Changes in Moisture-Proof Bag DiskOnChip P3

Product Update, March 2004
Amir Fridman (amir.fridman@m-sys.com)

Figure 2: New Instructions

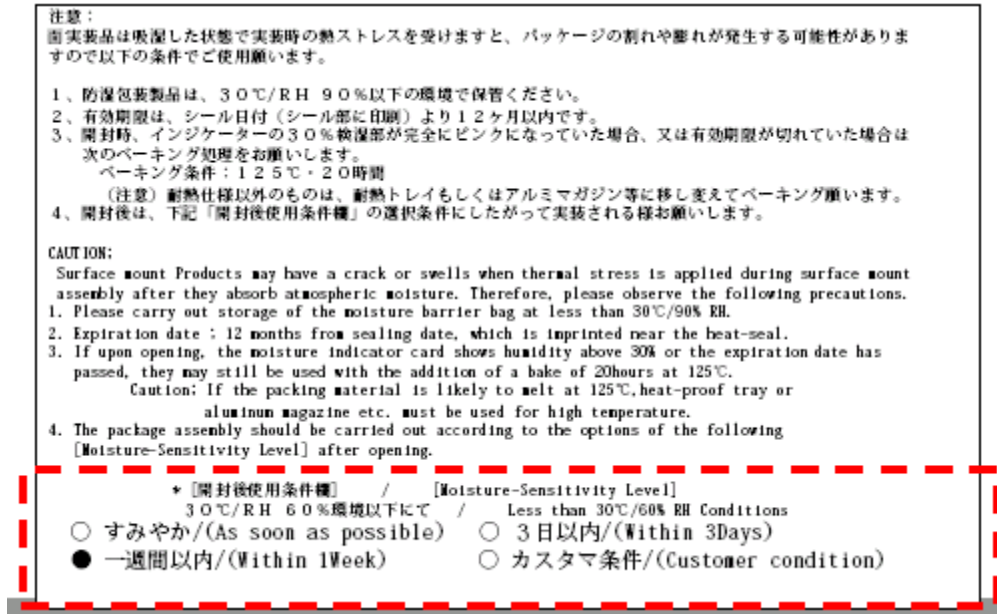
- Printed instructions for use after opening will be added. The new instructions are shown in Figure 2 and Figure 3.
